SAMPLE REPRESENTATIVE OF PRODUCTION

DECLARATION OF DIFFERENCES

Model No.: DVD-LX95

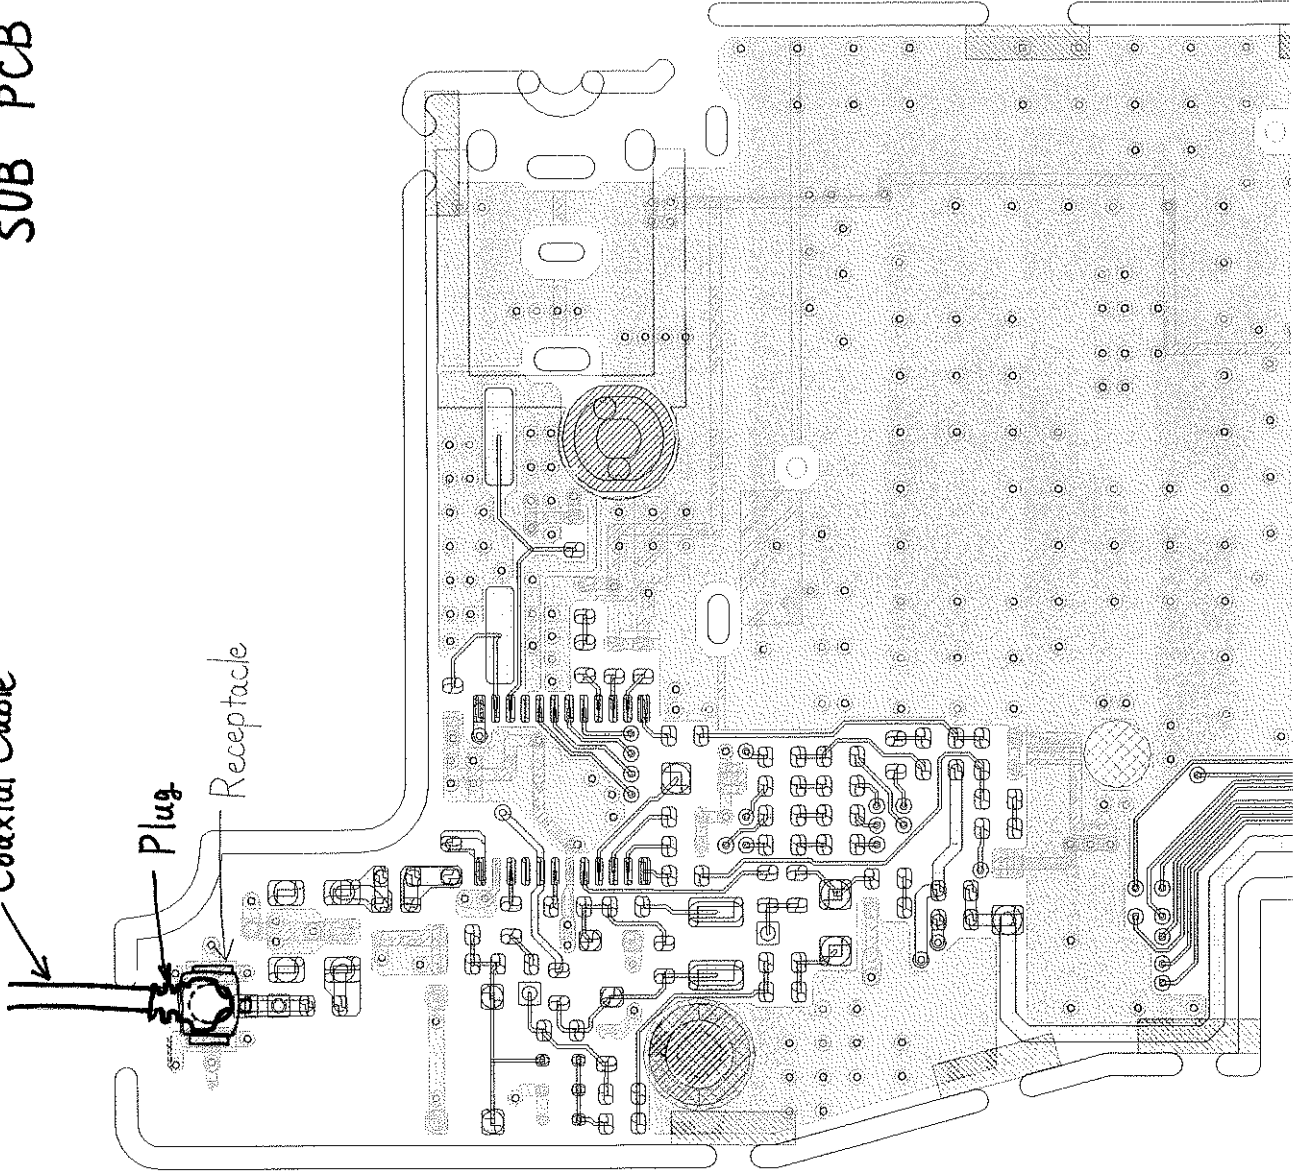
Substitute Features	Details of Differences	
	Representative	Production
Connection method of Coaxial Cable of FM Transmitter Antenna	<ol style="list-style-type: none"><li>1. Coaxial Cable with Plug.</li><li>2. Receptacle (connector) on PCB.</li><li>3. Coaxial Cable and PCB is connected by Plug and connector.</li></ol>	<ol style="list-style-type: none"><li>1. Coaxial Cable without Plug.</li><li>2. Without Receptacle (connector) on PCB.</li><li>3. Coaxial Cable is soldered to PCB directly.</li></ol> <p>Please refer to the drawing of sample representative and production.</p> <p>This method will be implemented by running change in mass production.</p>
